**SECTION 00 90 02
BIDDING AND CONTRACT REQUIREMENTS
ADDENDUM NUMBER 2**

Issued: November 1, 2024

Re: ADDENDUM NUMBER (2) TO THE BIDDING DOCUMENTS FOR

**McHenry County College
2024 Renovations – Bid Package 2**
Architect's Project Number: 24-013

20 PLAN DETAIL
1 1/2" = 1'-0"

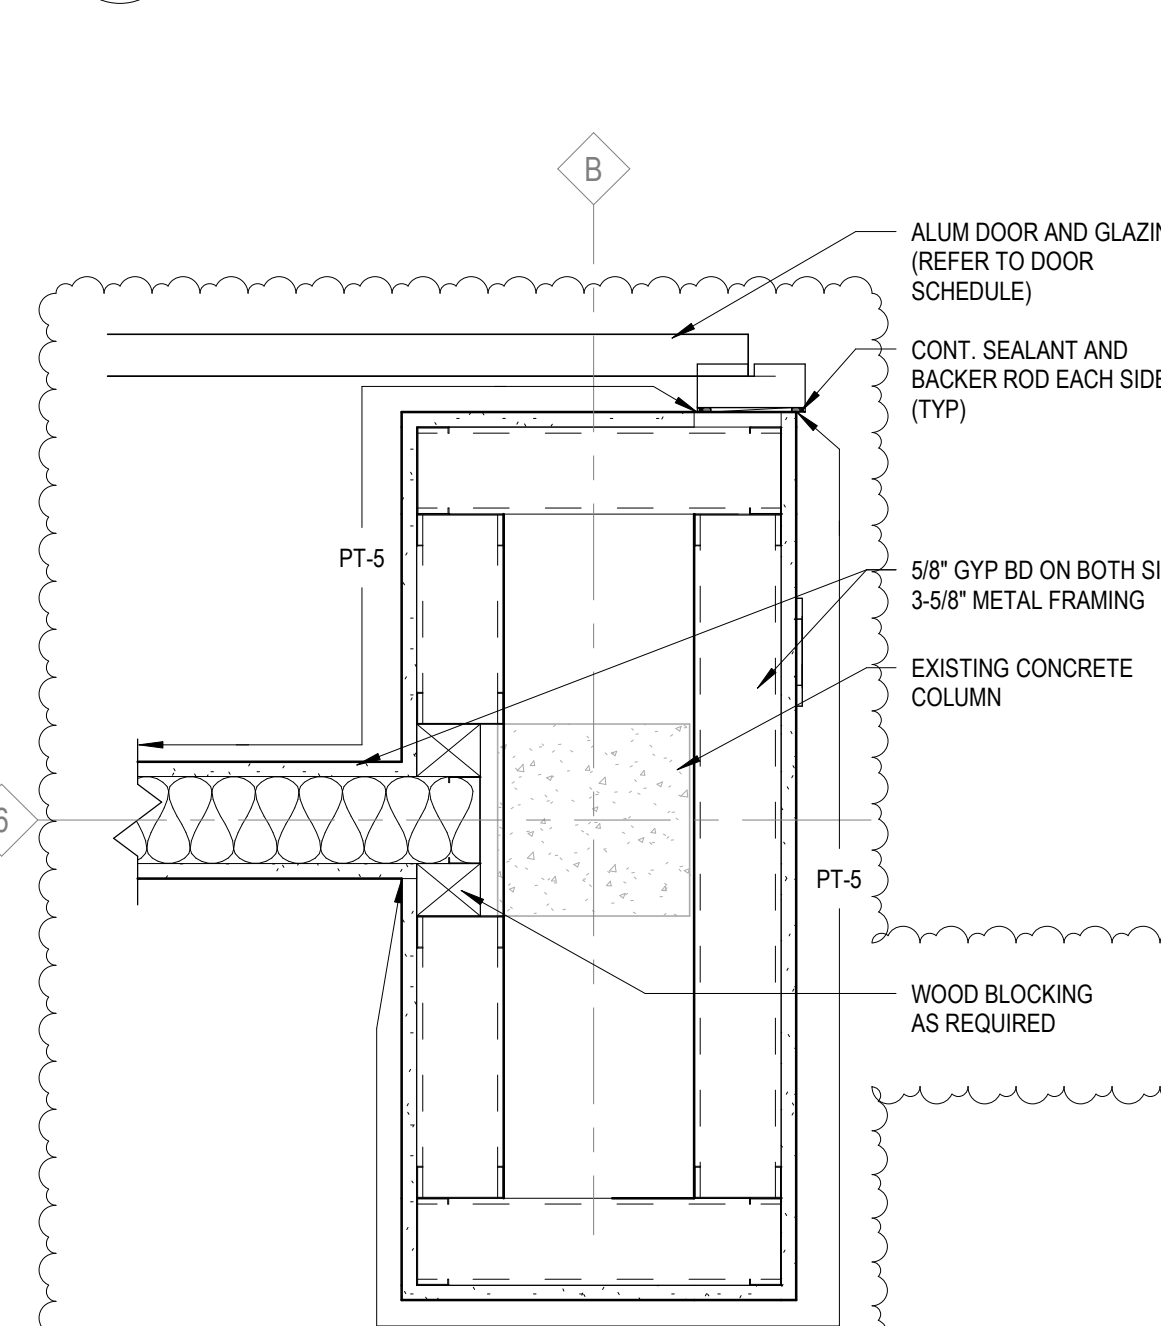
- I. **ADD** referenced note 18 and 19 to clarify scope associated with Fire Rated Folding Door.
7. A7.01
 - A. **REVISE** detail 20 as indicated.
8. A7.02

A9.52

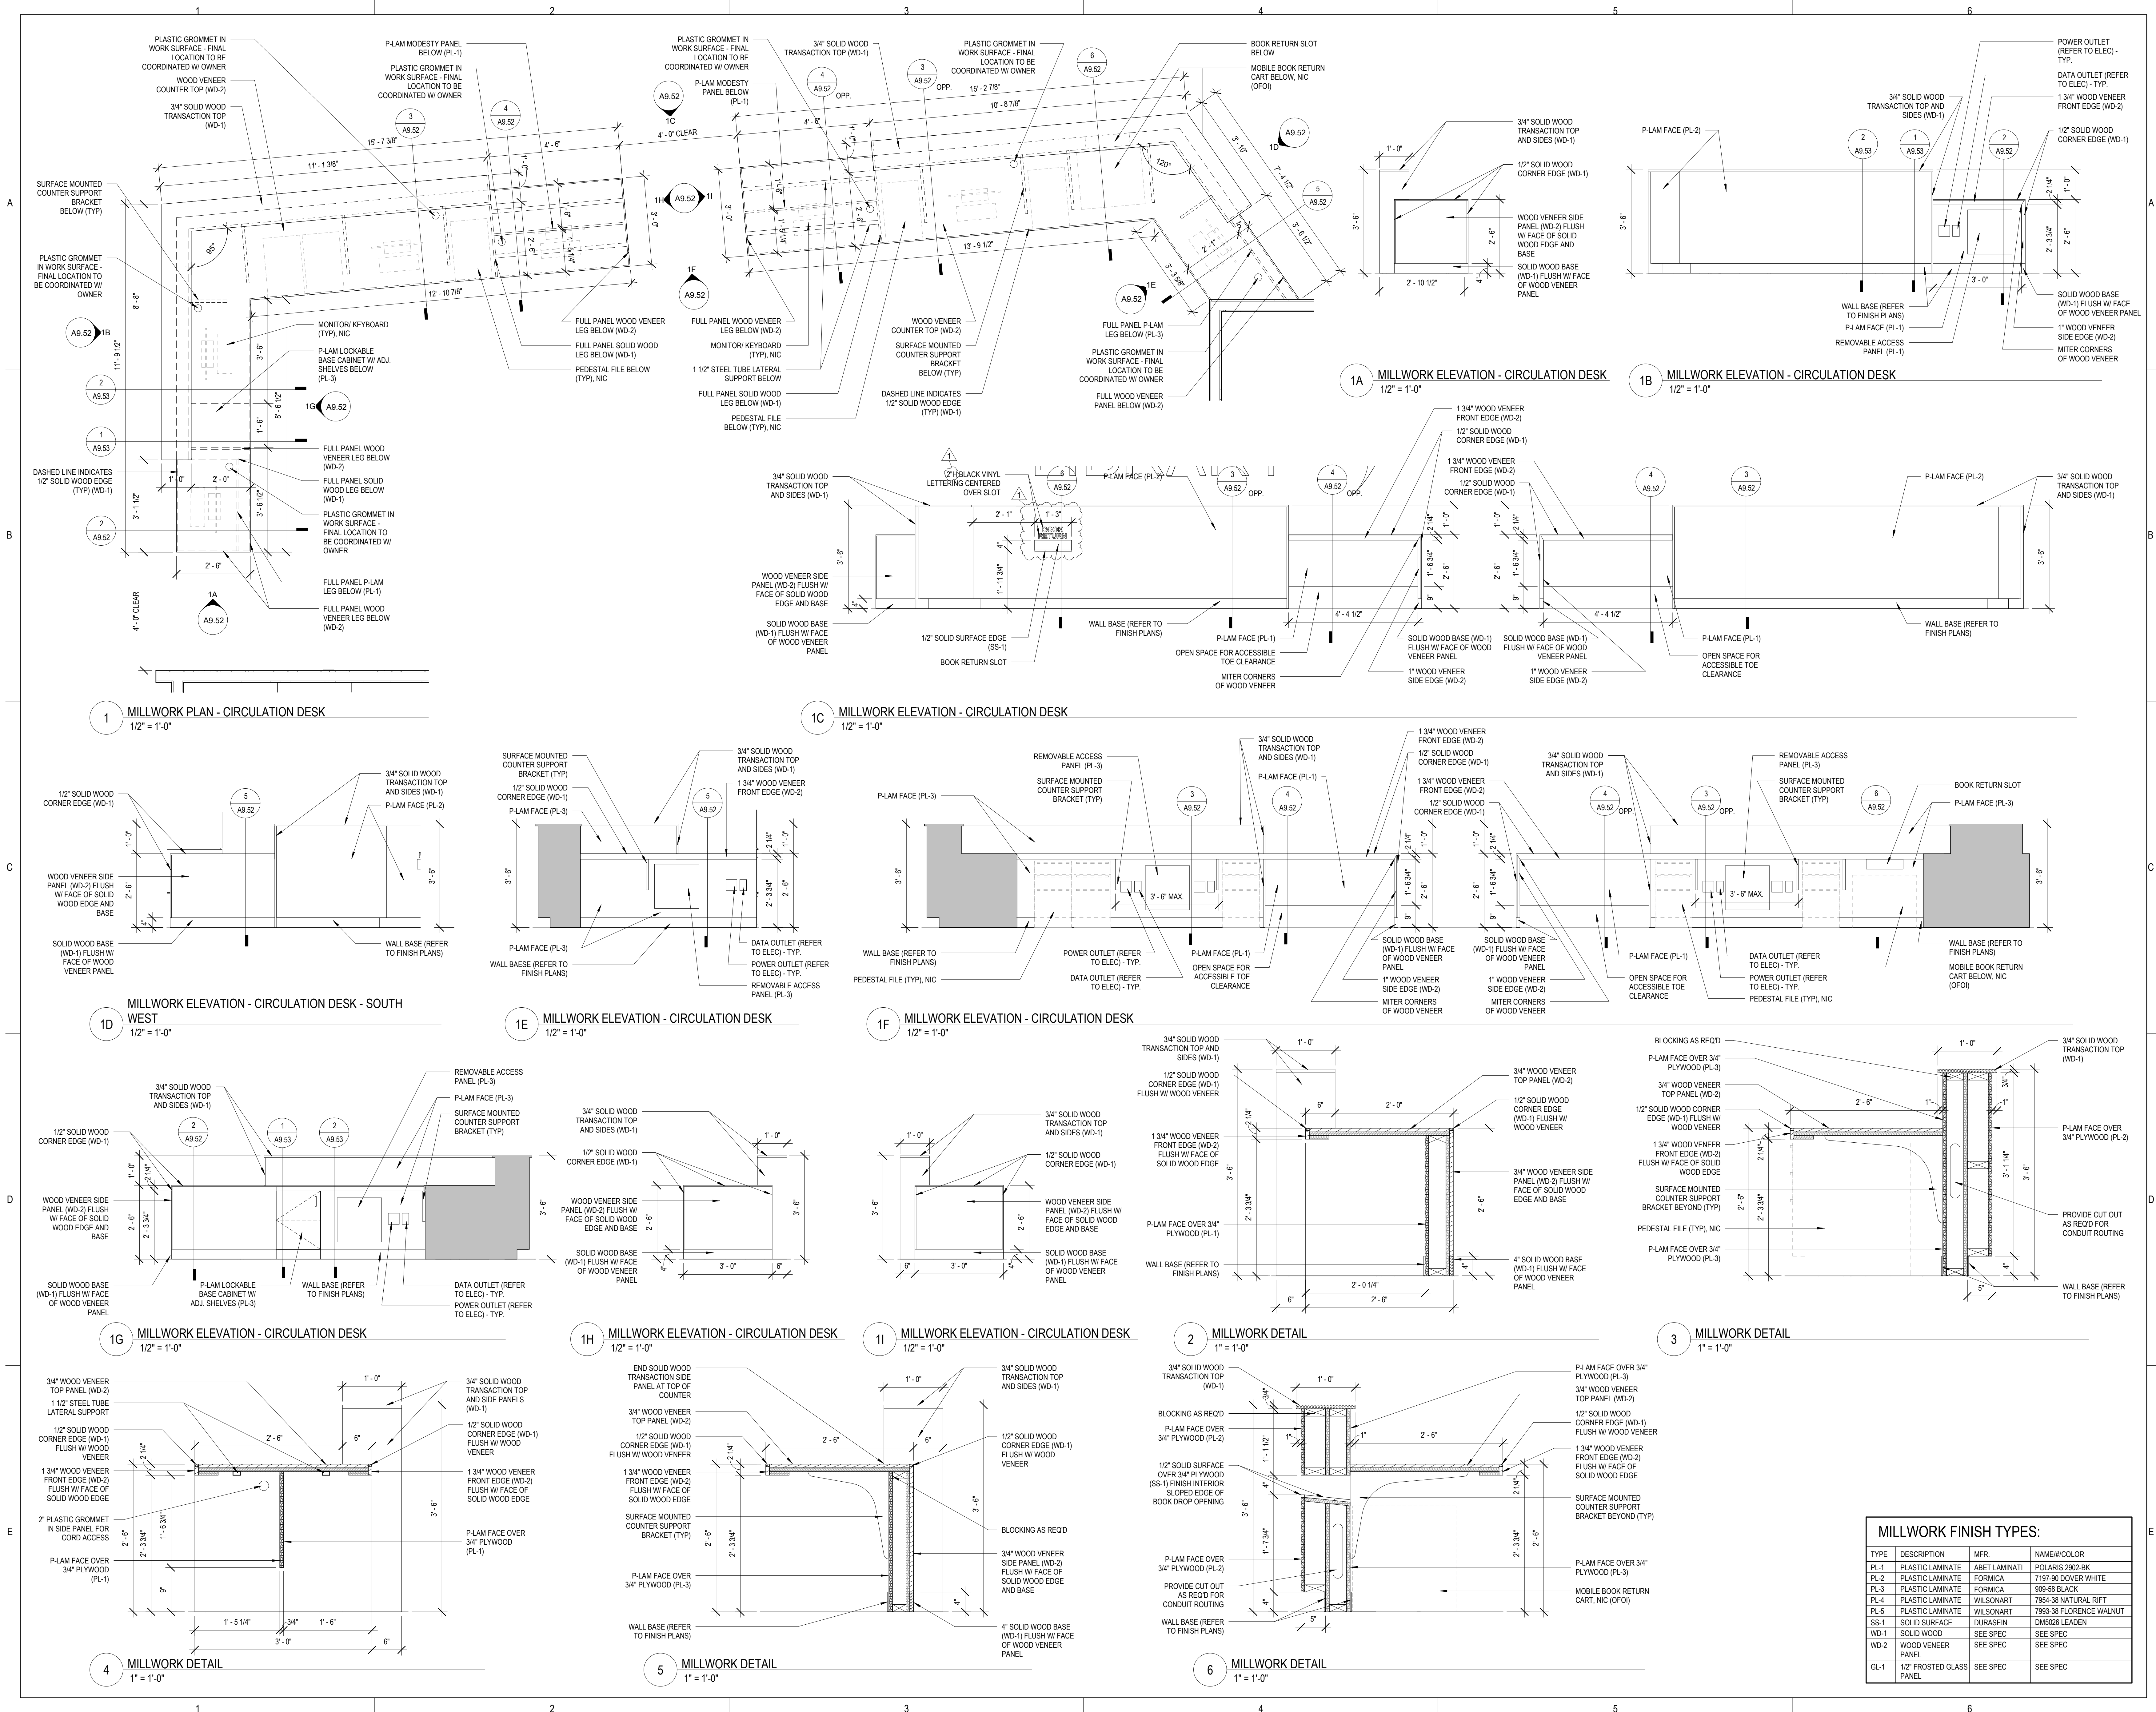
10. A9.52
 - A. **REVISE** size of Book Return opening from 1'-6" wide to 1'-3" wide on Millwork Elevation 1C.
 - B. **REVISE** size of vinyl Book Return lettering from 4"H to 2"H on Millwork Elevation 1C.

STRUCTURAL REFERENCE SHEET

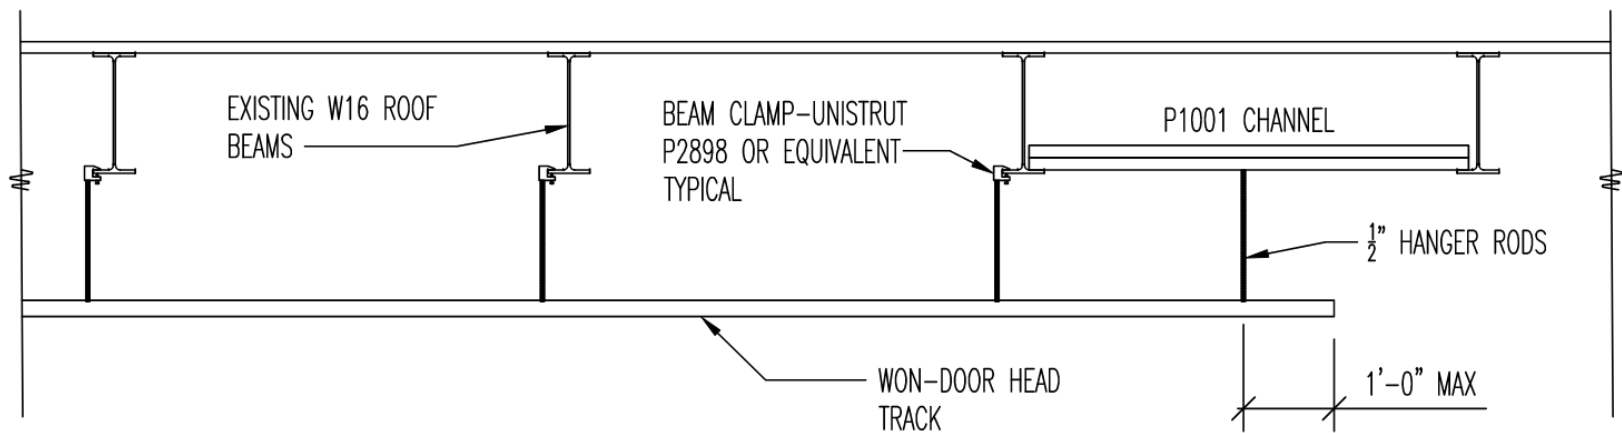
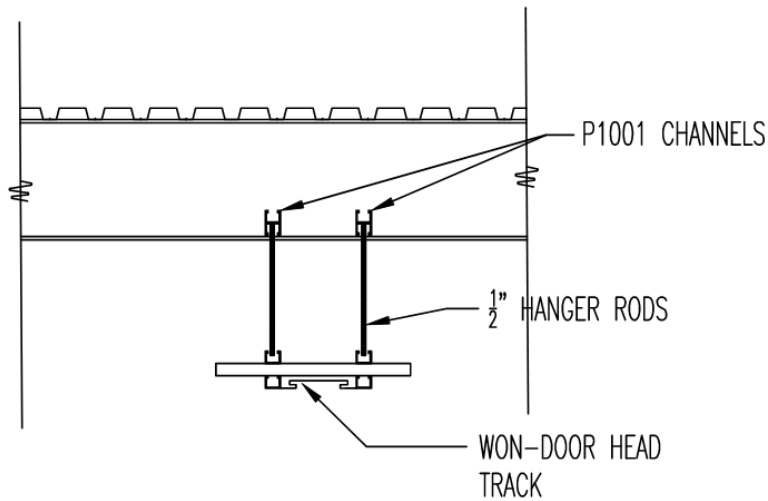
- 1. Structural Reference Sheet
 - A. **ADD** structural reference sheet in its entirety to provide attachment details for Fire Rated Folding Door at the Library in Building A, 2nd Floor.

E1.11

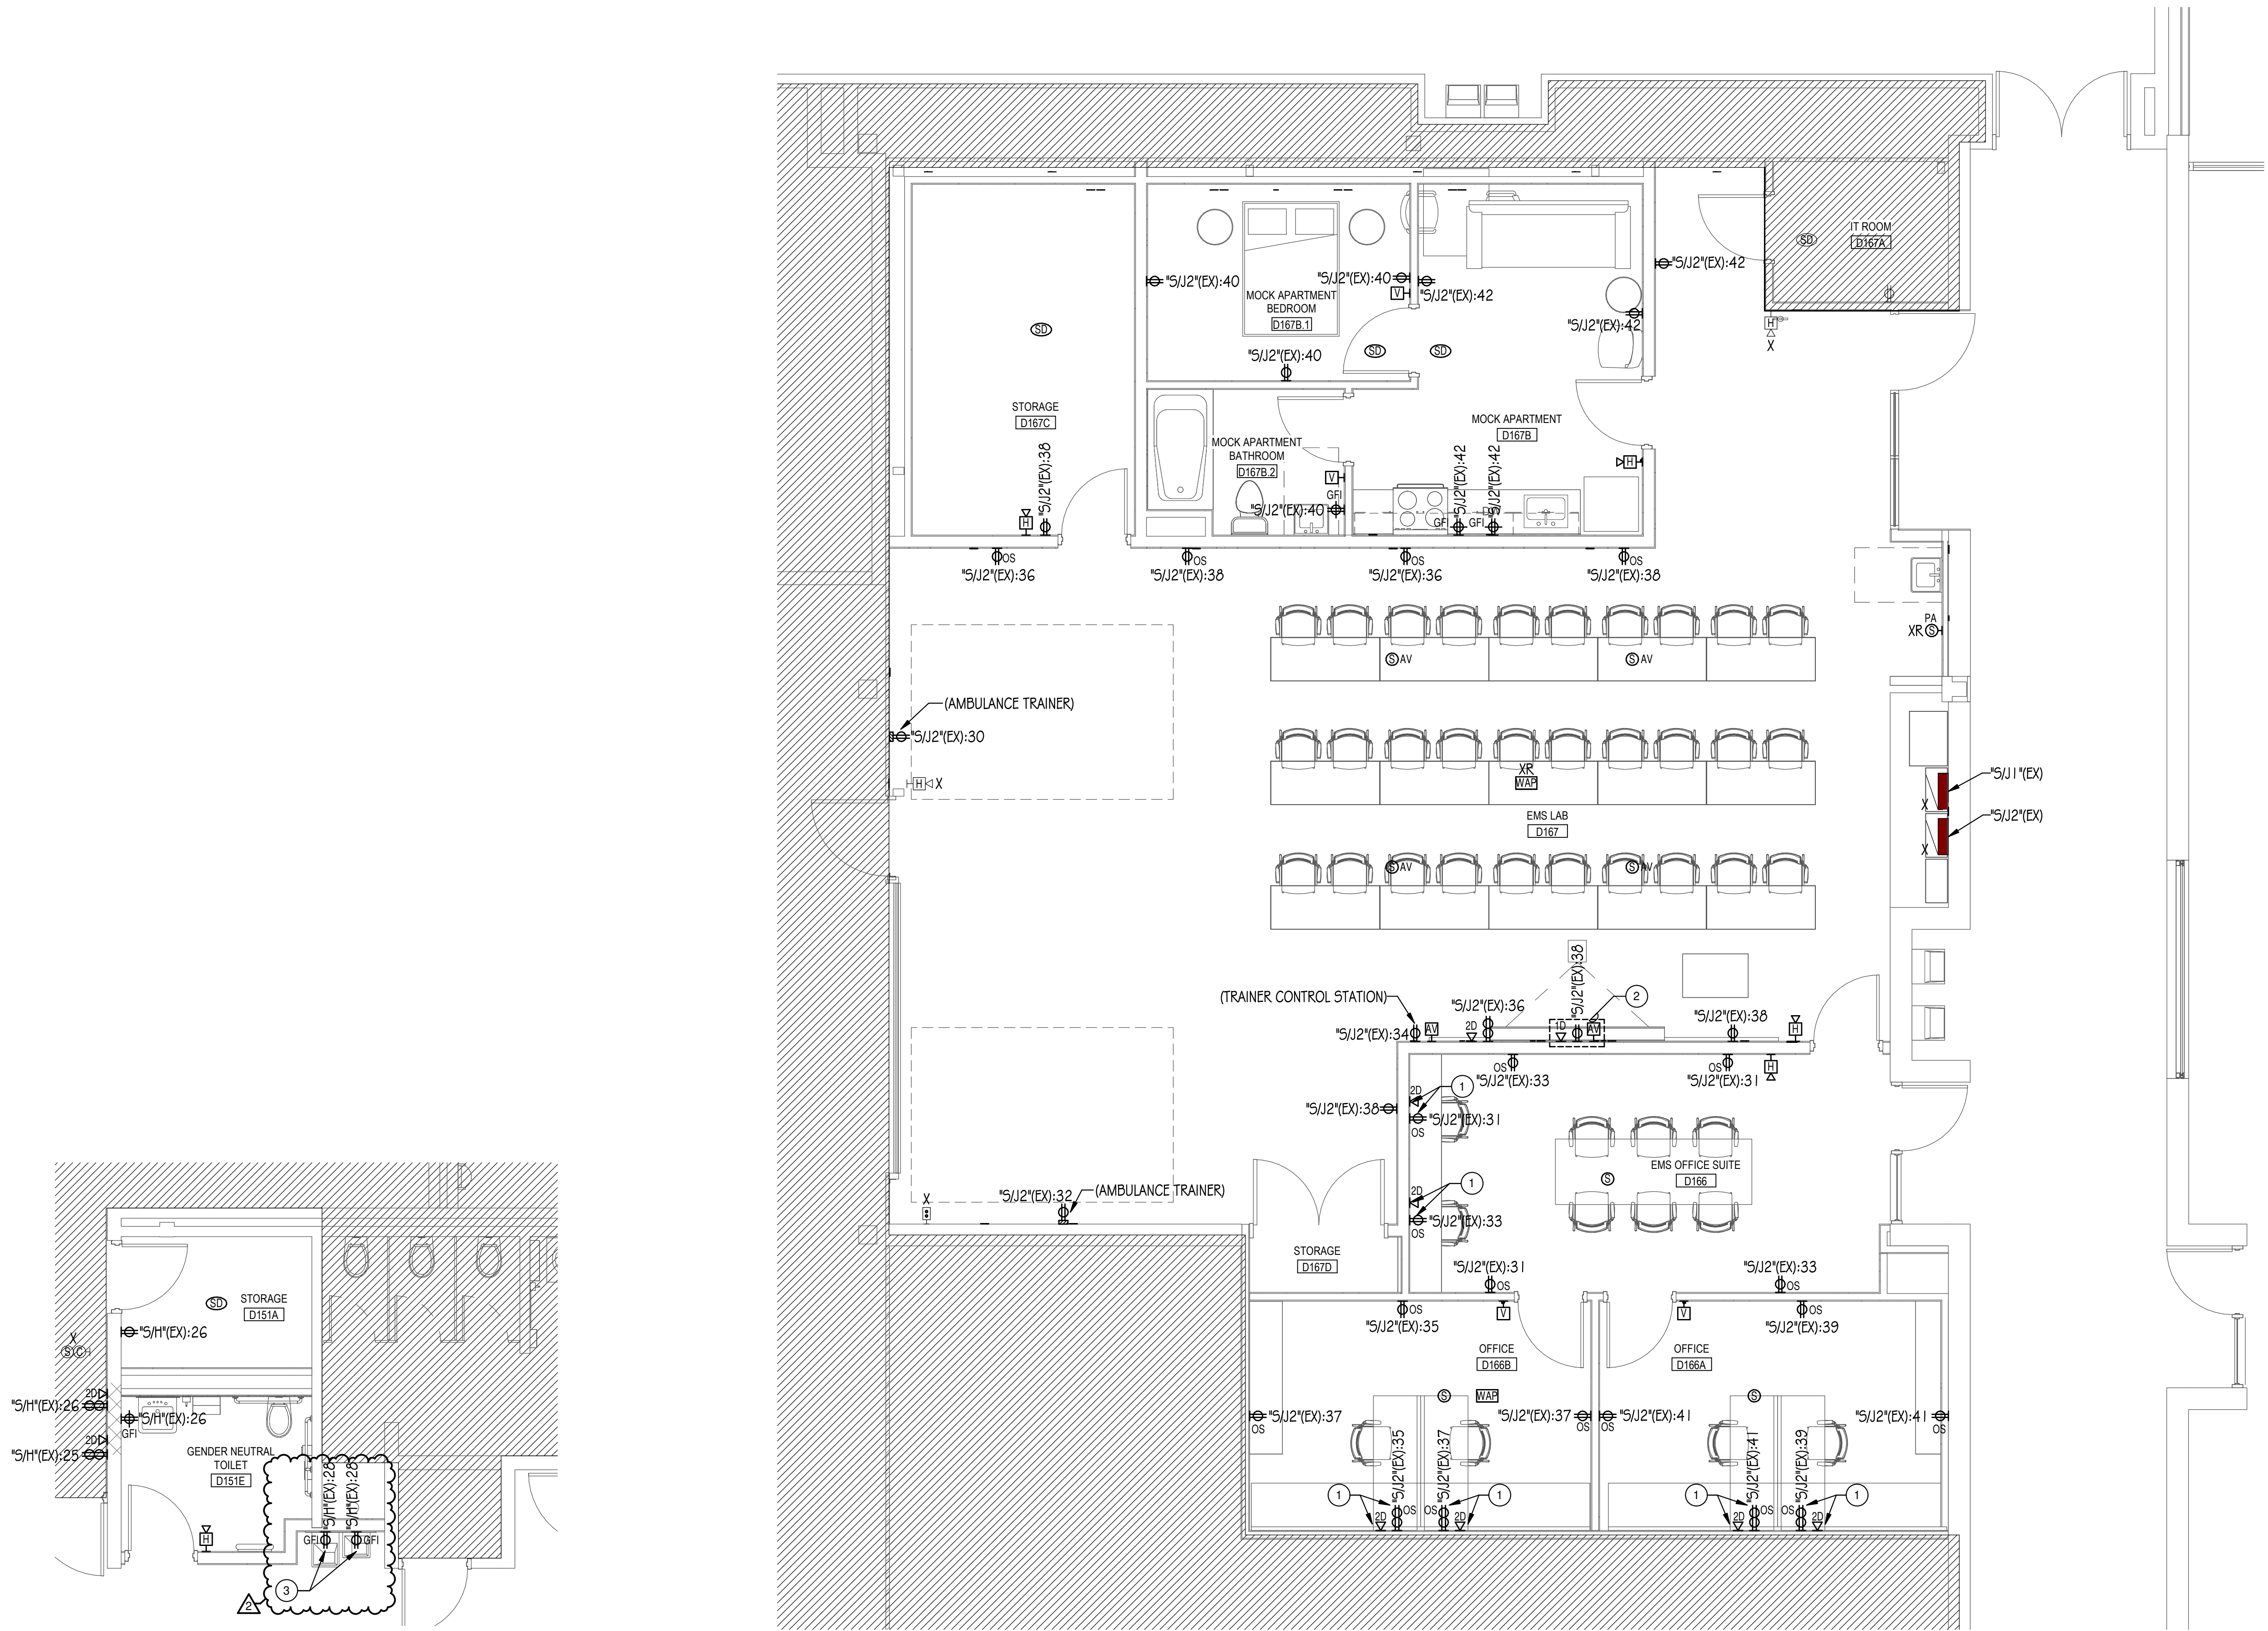
- C. **REVISE** note regarding server room cooling system replacement.
 - D. **ADD** general notes to drawing.
- 2. E1.11
 - A. **ADD** receptacles serving electric water cooler and associated drawing note located outside Gender Neutral Toilet D151E.
